THE DETAIL IS IN THE DECAL

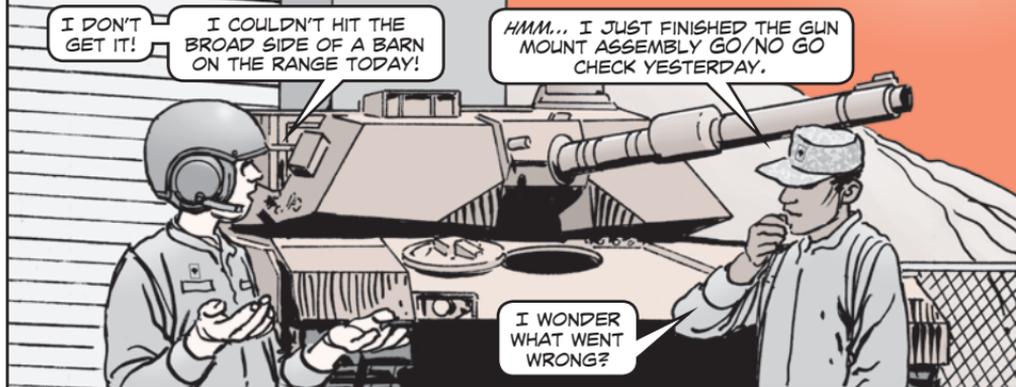
But wait! Turns out there's a problem with those directions.

Step 3 on the decal says to read the top of the coax ammo feed chute against the scale on the gage. But the gage was redesigned some time back, so you should now be reading the **top of the breech block** against the gage.

A new decal, PN 9376991-1, has been designed and will soon start appearing on tanks coming out of RESET. Unfortunately, the decal isn't available in the supply system yet.

Until it is, use a permanent marker to cross out **COAX AMMO FEED CHUTE** on the current decal's step 3. Then write in **BREECH BLOCK** in its place. That'll help prevent using the wrong measurement for the semiannual check.
